CITY PLANNING COMMISSION

- APPLICATION:
1. Environmental Determination
  2. Tentative Map to resubdivide 2.0± vacant acres into eight single family lots in the R-1 zone.
  3. Variance/Subdivision Modification to create substandard lots

LOCATION: 600' southeast of Riverside Boulevard and 13th Avenue

P83-343

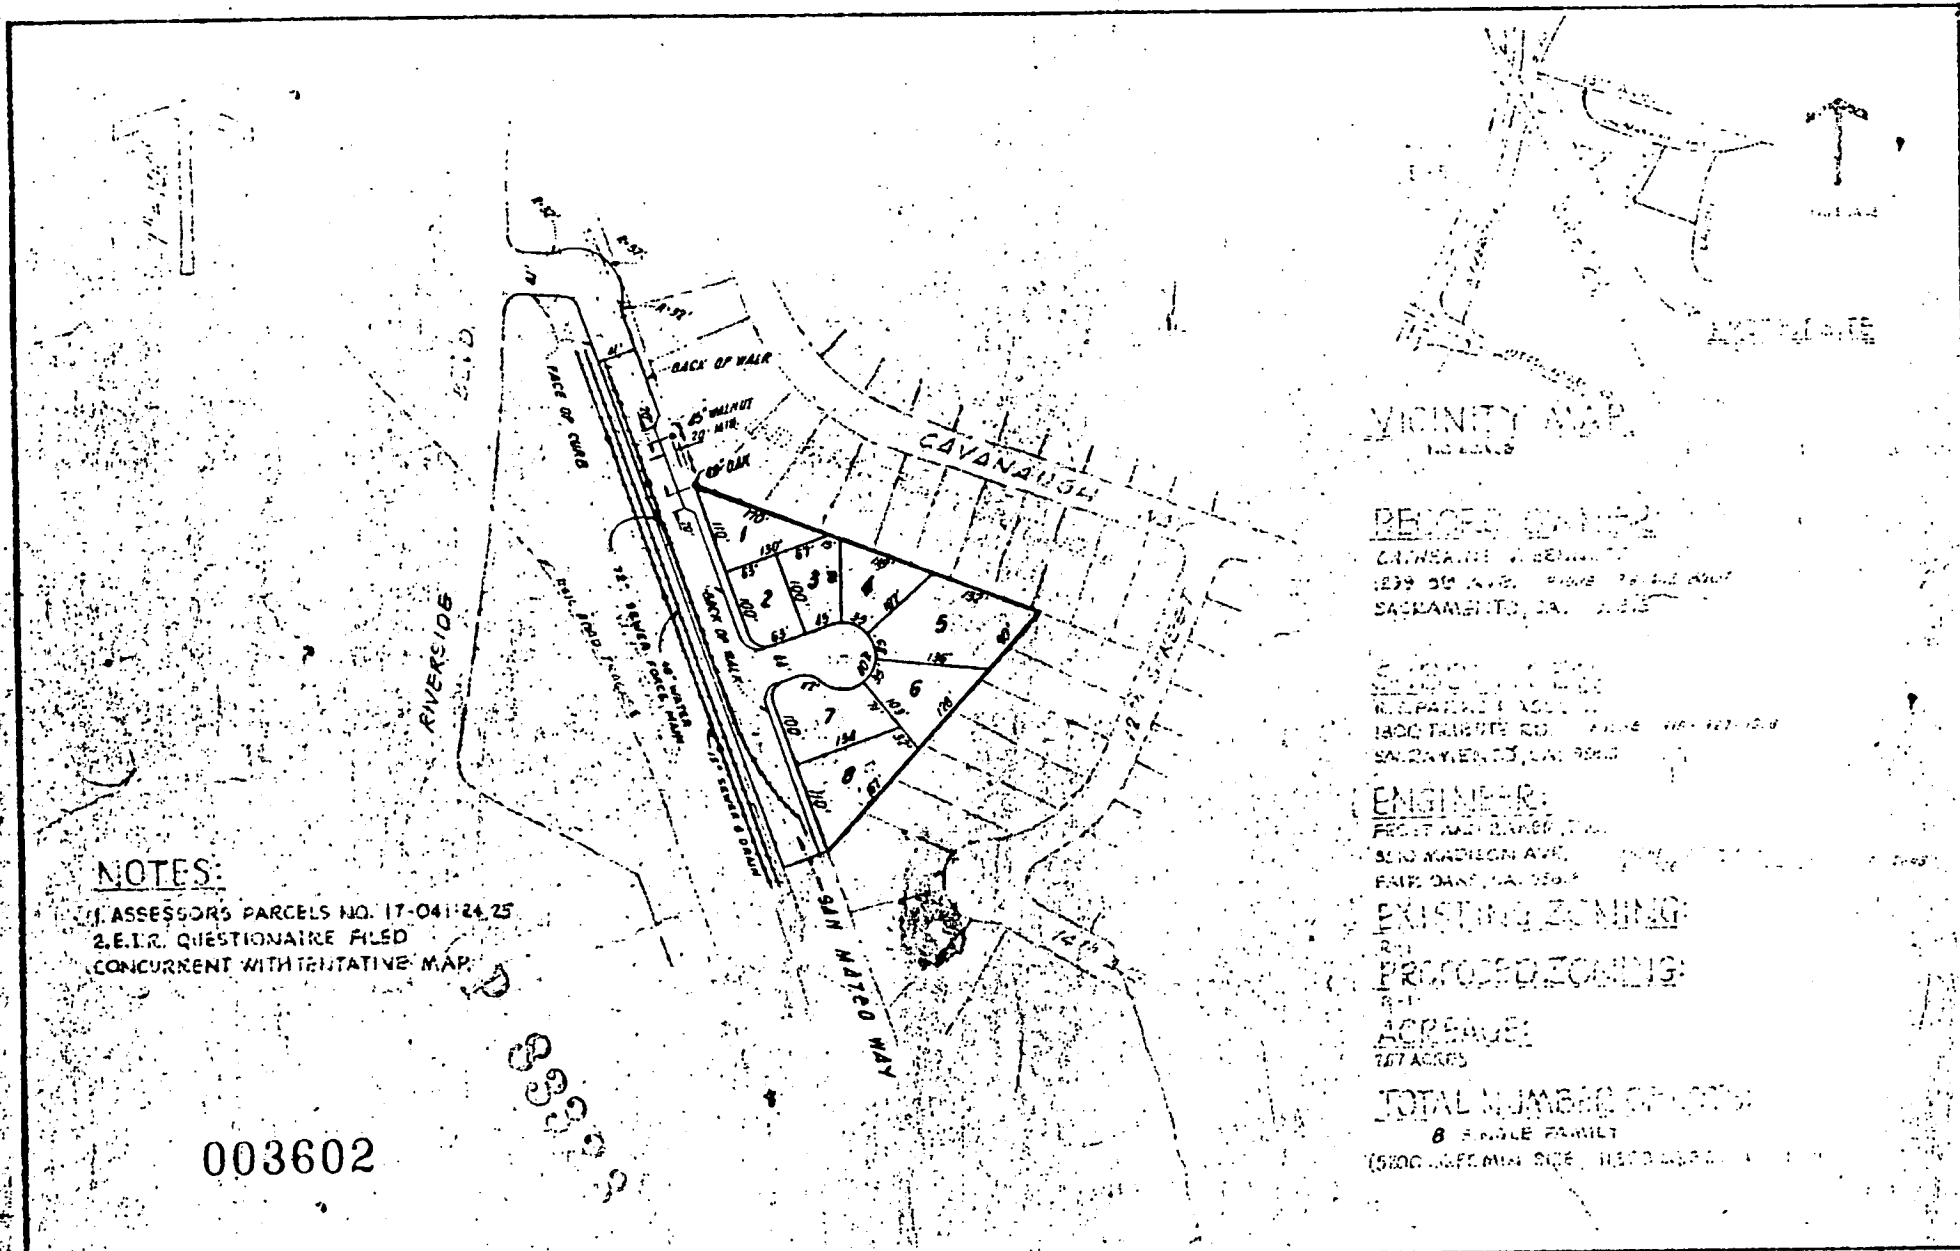
1. In reference to the variance/subdivision modification, the applicant is proposing to create one lot with less than 100 feet in depth. Staff has no objection to this request because the site is an irregular shaped lot which makes it difficult to meet all requirements of the Subdivision Ordinance.
2. The subject site is a landlocked parcel and surrounded on three sides by existing single family development. At the present time access to this site

is via a piece of City-owned property. The applicant is proposing to construct a street on the City's property which will connect the subject site and Riverside Boulevard. The street will have to be designed with a 50 foot right-of-way section; however, sidewalks will be required on the east side only. The curb to curb width is 36 feet. The 36 foot curb to curb is necessary because there is a baseball park located south of the subject site and access to this park is also along the City-owned property. Vehicles utilize the City property for parking during usage of this ball park, and it is anticipated that the proposed access street (San Mateo Way) will be utilized for parking.

3. The proposed use of the site is compatible to surrounding land uses. There are existing single family dwellings to the north, south, and east. There are several lots which are irregular in shape, however, it is unavoidable in this case because of the triangular shape of the site.

- a. Provide standard subdivision improvements pursuant to Section 40.811 of the City Code;
- b. Prepare a sewer and drainage study for the review and approval of the City Engineer;

- c. Pursuant to City Code Section 40.1302 (Parkland Dedication), the applicant shall submit to the City an appraisal of the property to be subdivided and pay the required parkland dedication in-lieu fees. The appraisal shall be dated not more than 90 days prior to the filing of the final map;

- d. Improve San Mateo Way from Riverside Boulevard to subject site with 36 feet from curb to curb and sidewalks on easterly side of street to the satisfaction of the City Engineer. Improve west and south side of street with curb and gutter only (off-site improvements may be required);

- e. The existing and proposed water and sewer easements shall be shown on map;
- f. The following trees shown on the grading plan shall be retained unless it is determined by the City Arborist that the trees are diseased or not significant:

2 - Heritage trees located north and just off-site along the east side of San Mateo Way. The applicant has jogged the road alignment of the access road (San Mateo Way)

2 - Oaks on Parcel 1

3 - Oaks on Parcel 2

3 - Gums, 1 Poplar on Parcel 5

5 - Oaks on Parcel 7

4 - Oaks on Parcel 8

There shall be no grading (fill or removal) parking, or storage of vehicles or construction materials within the drip line of the specified trees, in order to assure there will be no spills, compaction, etc that could be detrimental to the trees;

Removal of any bushes, as noted on grading plan, shall not disturb the above mentioned trees or their root systems.

- g. Provide a water main extension and fire hydrant along San Mateo Way, subject to the review and approval of the Director of Public Works.
